NUMBER: 18-023-15 REV.C

DATE: October 12, 2015

Flash: 3.0 L MIL Illumination Diagnostic and System Improvements

2014 (WK) Jeep Grand Cherokee

Fig. 1 EGT Sensor Bank 1 Sensor 1

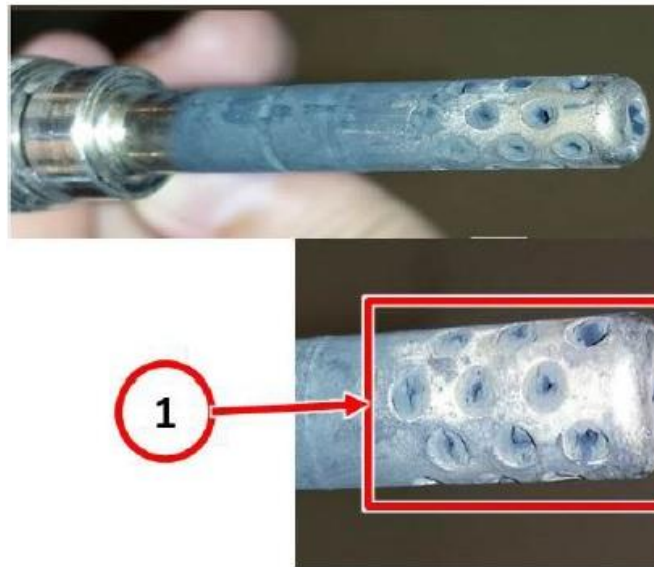
11. Inspect the sensor body and probe for any signs of damage or excessive soot. See (Fig. 1).

1 - Excessive soot blocking sensor ports

-
12. Was excessive soot found on the sensor?
- Yes>>> Proceed to [Step #13](#).
 - No>>> Proceed to [Step #14](#).
13. Using shop air set to a maximum of 80 psi, clean all excessive soot from the sensor probe.

14. Using a suitable multi-meter with appropriate test probes, test the resistance between the sensor connector terminals 1 and 2. With the sensor at room temperature, 65-75 °F (18-25 °C), the resistance should measure between 200 and 240 ohms.
